**Meeting:** 11/19/2025  
**Applicant:** Logan Higgins Heyoh Architecture  
**Owner:** Logan Higgins Arlington Downs Partnership, LLC  
**District:** Oakwood/Lincoln Park Infill Housing Overlay District

**Location:** 3547 Oswald St. **Parcel ID:** 69 N E 00401  
**Zoning:** I-MU (Industrial Mixed-Use)  
**Description:** Revisions to multi-family building (8-G-23-IH) and new plat

**9-F-25-IH**  
**APPLICATION FOR CERTIFICATE OF APPROPRIATENESS**

# ARLINGTON DOWNS 1.2

Resubdivison Plat of Lot 1R of Arlington Downs

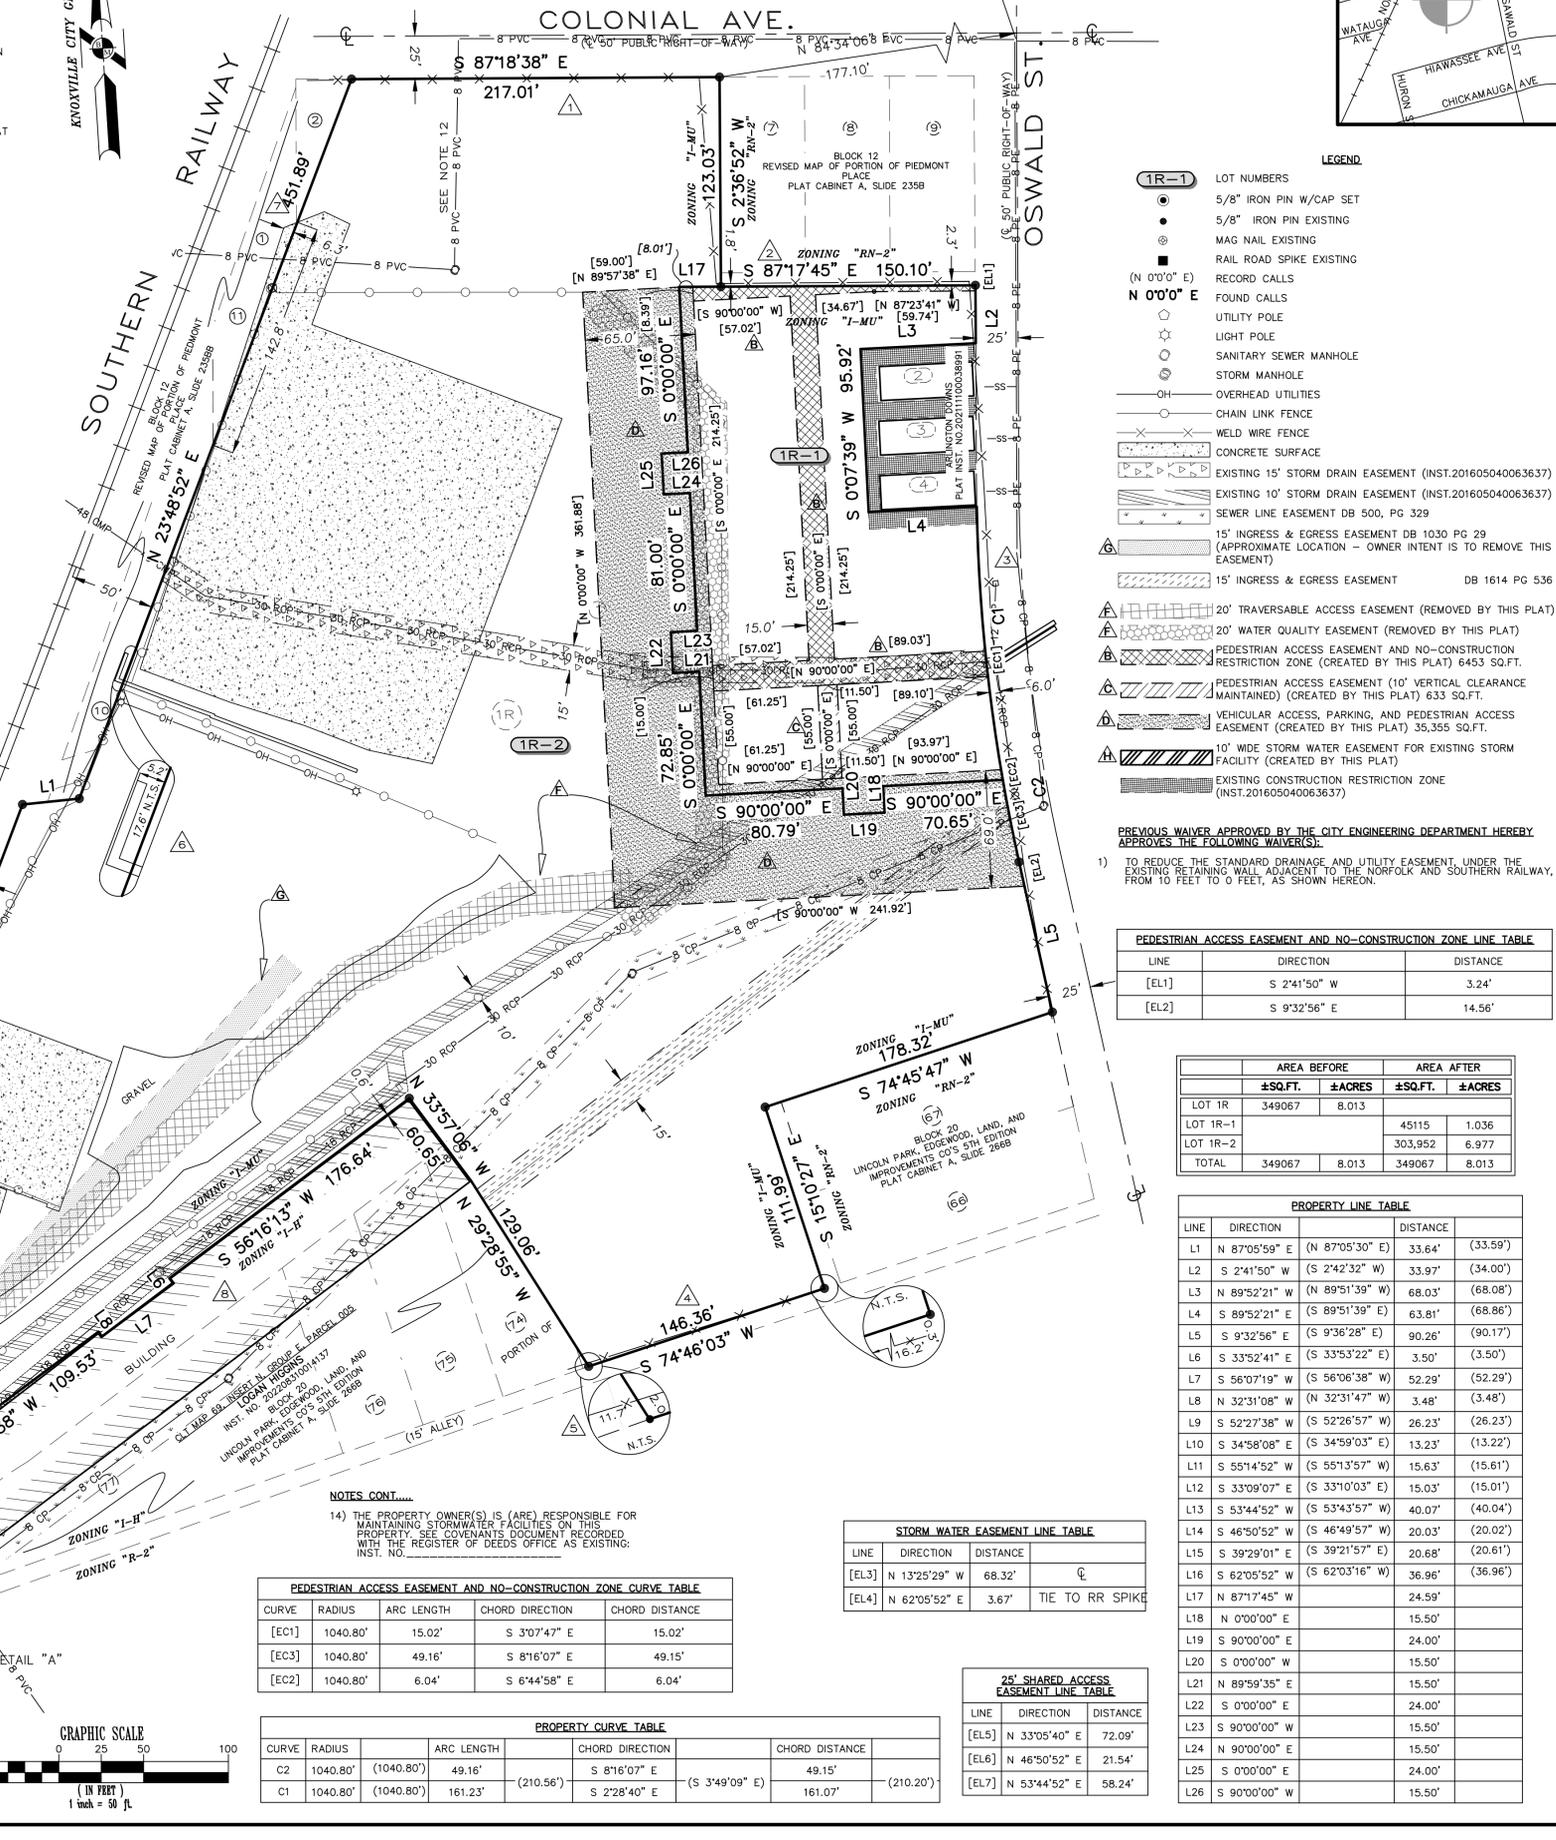
2. The proposed plat creating two lots from the current 8.01-acre lot requires approval from the Board because it does not create 50’ wide lots. The property has an irregular shape and was historically an industrial site, so it does not have a historic residential development pattern. The proposed plat creates two new lots that follow the boundaries of the proposed site plan and existing exterior lot lines. Pedestrian and vehicular access easements have been added to reflect the pedestrian amenities indicated on the site plan. The proposed plat is appropriate. It makes residential development easier on the site, could be subdivided into 50’ lots if the project did not happen, and would not increase the scale of any possible non-residential use of the site.

- 4) the final plat to meet the Subdivision Regulations, with major changes to return to the Board;
  - 5) the final site plan to incorporate walkways from the porches to the street or sidewalk required landscaping in the “intermediate” parking area and all elevations, including native or naturalized ornamental or shade trees along Oswald Street, with final selection and placement to meet any applicable standards, including Article 12, and be sent to staff for approval;

PHASE 1.2A  
 PLAN

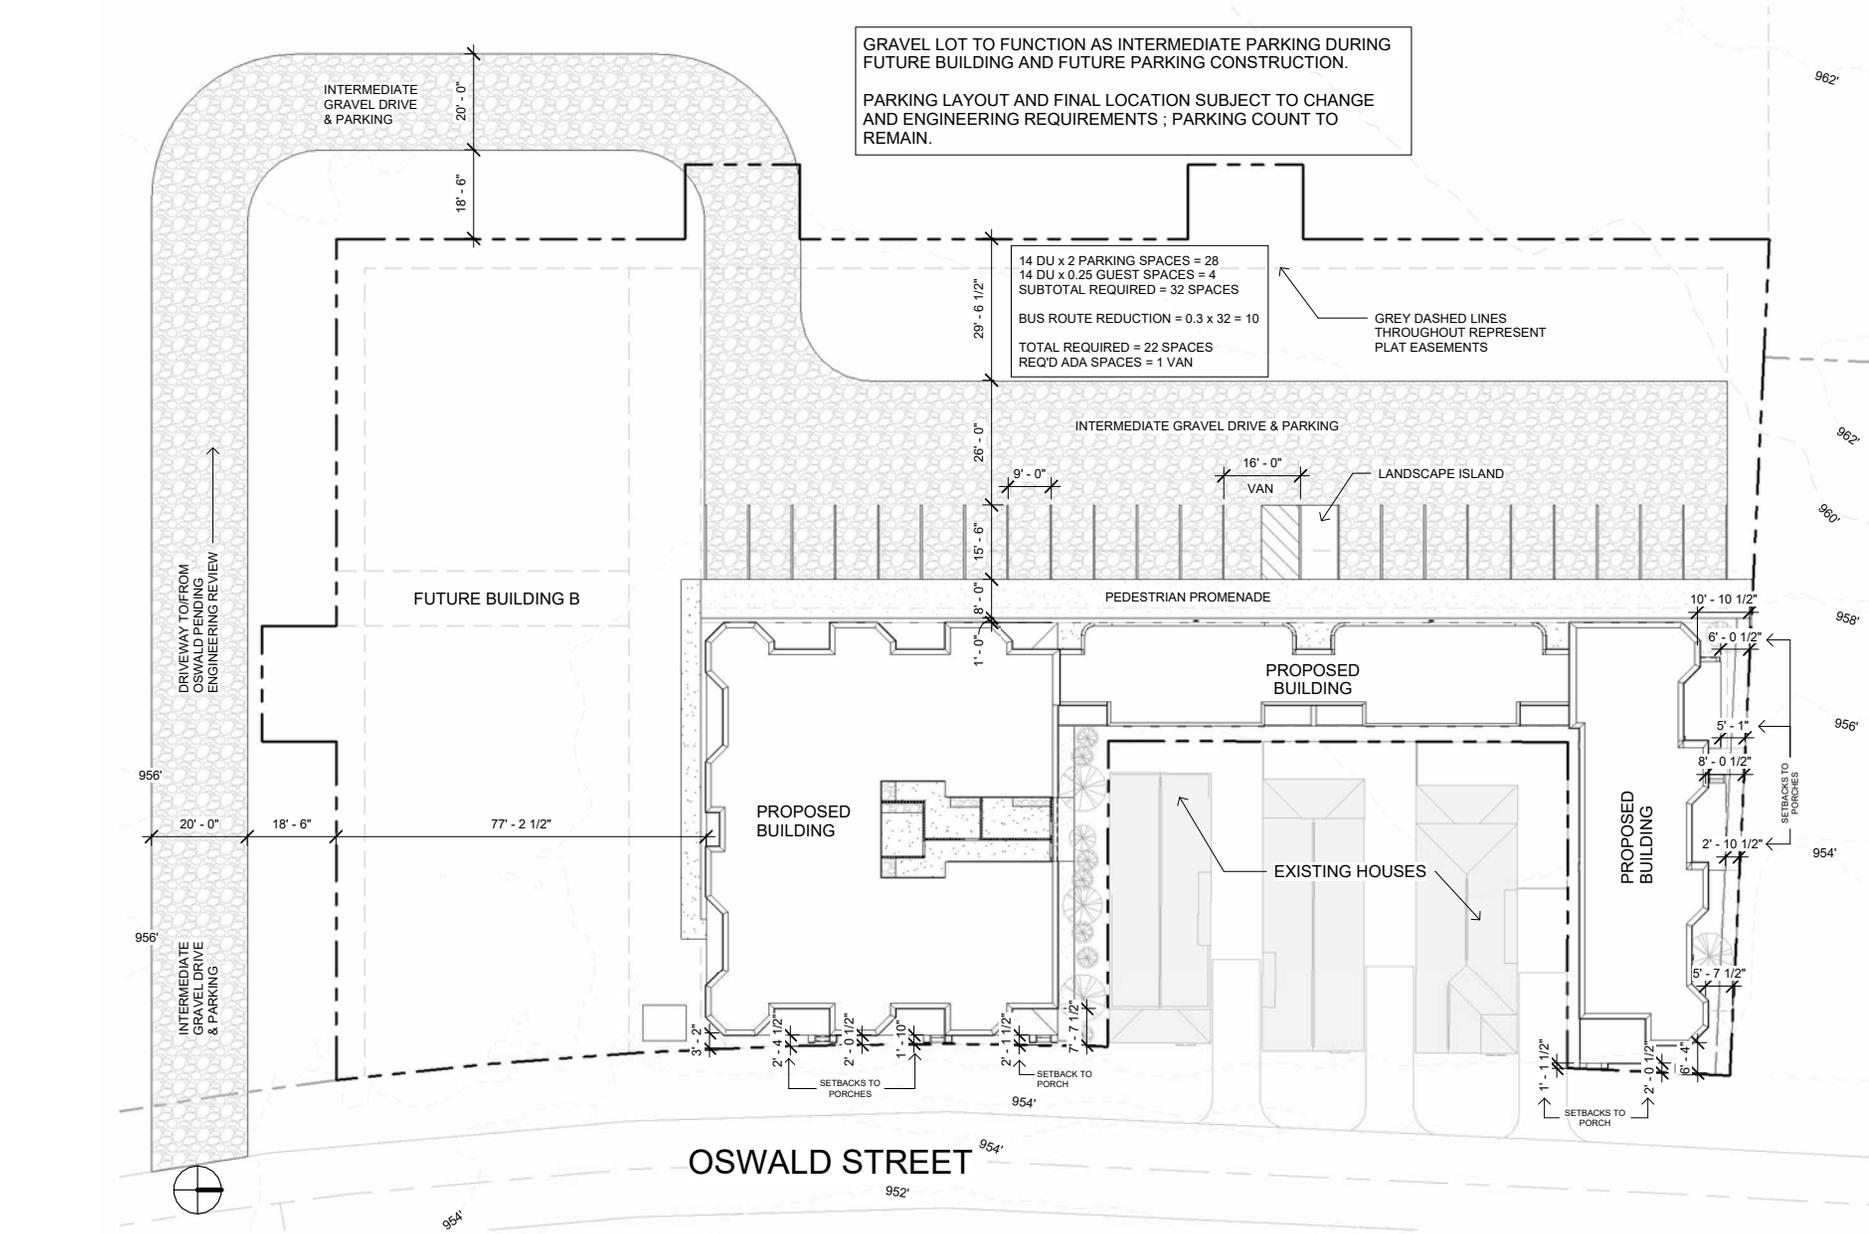
4. Parking is now provided via an "intermediate gravel drive and parking" area shown on the Phase 1.2A Plan (page 22), located to the rear (west) of the proposed buildings, with connections to Oswald Street with the same access as the "proposed future parking." The previous submittal also included a connection from Colonial Avenue. While the intent of this parking area to be temporary, it has to be considered as if it is permanent, meeting all zoning standards, since there is no guarantee if or when it will be removed. The gravel surface is an approvable driving and parking surface, pending approval by City Engineering. The parking is located behind the building and accessed via one lane, which meets design guidelines. With the exception of the proposed access point to Oswald Street discussed below, staff is recommending that the "proposed future parking" lot shown on the Overall Phase Site Plan (page 21) be approved as part of a future application since design details are likely to change based on future submittals.

The driveway location in relation to Rider Avenue has been corrected, showing that it is offset with the intersection. Due to this, City Engineering has indicated that exiting vehicles will be restricted to right-out turns only because of conflicting turn movements at the intersection. The driveway and parking lot drive aisle width on the "proposed future parking" area have been reduced to 26' width from 30' based on the plans submitted for the September 2025 agenda. The driveway curb cut width could be further reduced to 20', but this may not be possible because of the design requirements associated with restricting turn movements. The parking lot may be required to have a 25' setback from Oswald Street since it will serve a mixed-use development and has common frontage on the same block with residentially zoned property (Article 11.3.B).

- 2) City Engineering approval of the “intermediate gravel drive and parking” lot, its driveway access, and proposed sidewalks;
  - 3) the “proposed future parking” lot be approved as part of a future application;
